# Broadcast Products Technical Bulletin 20-2006-009

SUBJECT: NO POWER

MODEL: ***BVM-D14H1A***  
***BVM-D14H1E***  
***BVM-D14H1U***  
***BVM-D14H5A***  
***BVM-D14H5E***  
***BVM-D14H5U***

Figure 1

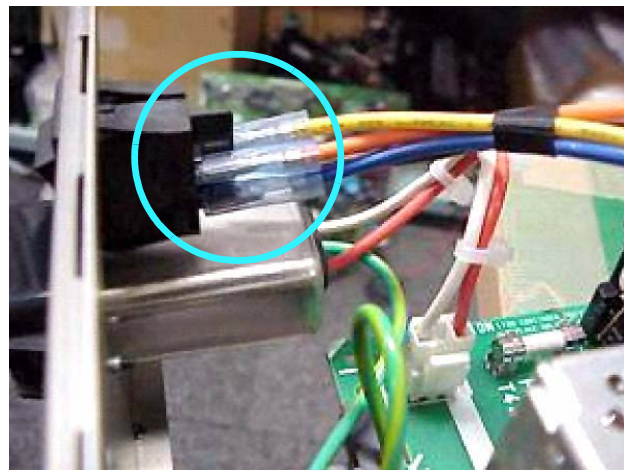
The connectors (FASTON terminals) on the AC POWER switch may not be locked securely when inserted. As a result, the terminals become disconnected, and power cannot be turned ON.

Replace the connector assembly (between CN602 and the AC POWER switch) with a new connector assembly. (See Figure 1.)

Part No.	Description	Qty.
1-910-000-76	VH Connector Assembly, 7-pin	1
